TO:	Bede Morrissey, Policy Planner, City Development
FROM:	Logan Copland & Trevor Watson - DCC Transport
DATE:	15 March 2022
SUBJECT:	VARIATION 2: DCC TRANSPORT RESPONSE TO REQUEST FOR COMMENTS ON DCC-PROPOSED GREENFIELD SITES

GF01: Part 155 Scroggs Hill Road, Brighton – Rezoning from Rural Residential 1 (RR1) to Large Lot Residential 1 (LLR1)

Figure 1: Potential Structure Plan proposed by Submitters

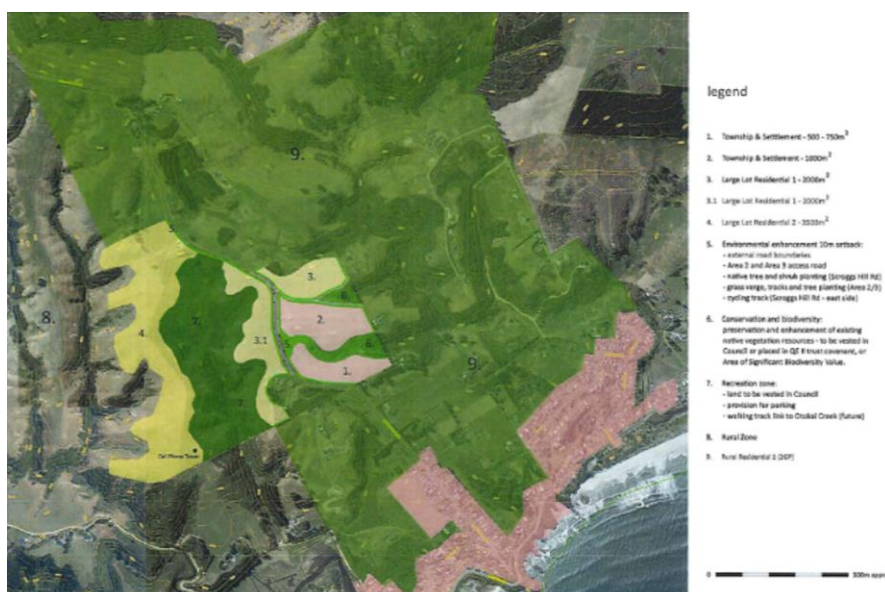
26. FS75.1 & FS75.2 state that 103A Scroggs Hill Road should not be included in any rezoning. They state that this property is down a leg-in driveway with access only via an easement

27. FS217.3 & FS217.4 oppose the rezoning of the rejected site areas shown above, and list transportation as a key reason for this opposition. They consider that the current transportation network is at almost peak, particularly the traffic up and down Seaview Road and also at the bottom of Scroggs Hill Road. They note that these roads are 'incredibly narrow' and there are multiple near misses on a regular basis. In their view, with more residents there will need to be some 'serious thought' around how traffic flow and risk will be managed.

28. In response to FS75.1 & FS75.2, capacity of a ROW is not something that would typically be considered as part of a rezoning proposal. The subdivision consent process provides the appropriate platform for these types of more detailed considerations.

29. In response to FS217.3 & FS217.4, it is noted that these concerns were noted by Transport in the assessment of the above GF01 site. These concerns would be amplified with the additional dwelling yields enabled by RS160 and RS220 (as described in Paragraph 20).

Figure 2: Plan showing RS160 and RS220 (note also the location of GF01 which has been evaluated above).

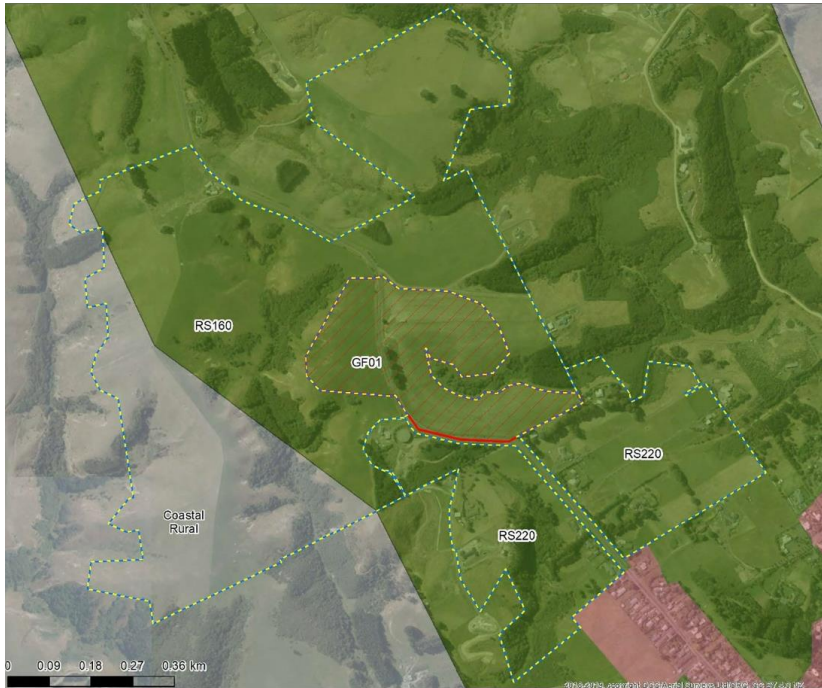
24. Figure 2 depicts the RS160 and RS220 areas, as well as GF01 which has been evaluated separately above. City Development have advised that the yield for RS160 on its own is yet to be determined. However, you have advised in an email dated 10/03 that the anticipated yield for RS220 is likely to be in the Range of 87-437 dwellings. However, it was further noted that should a rezoning be approved, the lower end of this scale is a more likely result.

25. Hence, assuming the areas within the submitter's Structure Plan **AND** RS220 were rezoned, a combined yield in the order of 244-694 dwellings would be the result. If GF01 was rezoned also, the overall yields would be in the order of 289-739 dwellings.

30. In the peak hours, it is anticipated that collectively, the rejected sites could generate between 220vph-625vph. Daily traffic movements could be between 2,000vpd-6,000vpd.

31. This would be traffic that is additional to that generated by the rezoning of GF01.
32. It is considered that this level of development would have a significant impact on the Council's road network, and no more detailed assessment of these impacts has been provided by the submitters.

33. Overall, it is considered that in the absence of any detailed transportation assessments, that even at the lower end of development generated by the rejected sites (should they be rezoned), that Transport would not be able to support these zone changes without significant Transportation infrastructure upgrades which may not be possible without land acquisition
